Providence City Plan Commission April 20, 2021

AGENDA ITEM 5 • 40 SEAMANS STREET

OWNER/APPLICANT: CASE NO./ PROJECT TYPE:	Joseph Colaluca c/o Admiral Properties LLC 21-007 UDR—Unified Development Review	PROJECT DESCRIPTION:	Subdivision of a lot measuring 8,000 SF into two lots measuring approximately 4,000 SF each with 40' of frontage in the R-2 zone. The minimum lot size for new subdivisions in the R-2 zone is 5,000 SF with a width of 50 feet. Pursuant to Unified Development Review, the applicant is seeking dimensional variances from minimum lot area and minimum lot width.
PROJECT LOCATION:	40 Seamans Street AP 79 Lot 11; R-2	RECOMMENDATION:	Approval of preliminary plan and dimensional variances
NEIGHBORHOOD:	Wanskuck	PROJECT PLANNER:	Choyon Manjrekar

Proposed subdivision

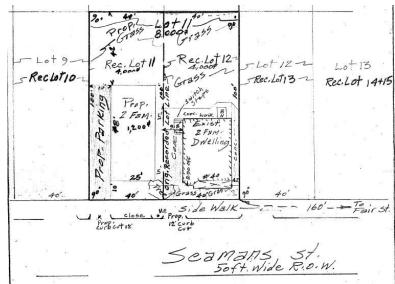
This proposal consists of subdividing the existing lot of 8,000 SF into two equal lots of 4,000 SF with 40 feet of frontage in the R-2 zone. The lot is currently occupied by a two family dwelling and a garage, which will be located on separate lots upon subdivision. The minimum lot size for new lots created by subdivision is 5,000 SF with a width of 50 feet. Pursuant to Unified Development Review, relief is being requested for minimum lot area and minimum lot width with preliminary plan approval for the subdivision.

New lots in the R-2 zone are required to maintain a minimum lot area of 5,000 SF and a width of 50 feet. As discussed, the subject lots will not meet these dimensional requirements. Pursuant to the CPC granting zoning relief, the subdivision will conform to the zoning ordinance. The subdivision meets the other requirements of the ordinance.

The applicant shall demolish the garage prior to final plan approval so as to not have the subdivision result in an accessory structure as the only building on a separate lot, which is prohibited by the ordinance. The subdivision is not expected to pose any constraints to development because each lot will be able to accommodate a two family

- 1. The applicant shall demolish the garage prior to final plan approval.
- 2. The validity of the preliminary plan should be extended to one year from the date of recording of the approval letter.
- 3. Final plan approval should be delegated to DPD staff.
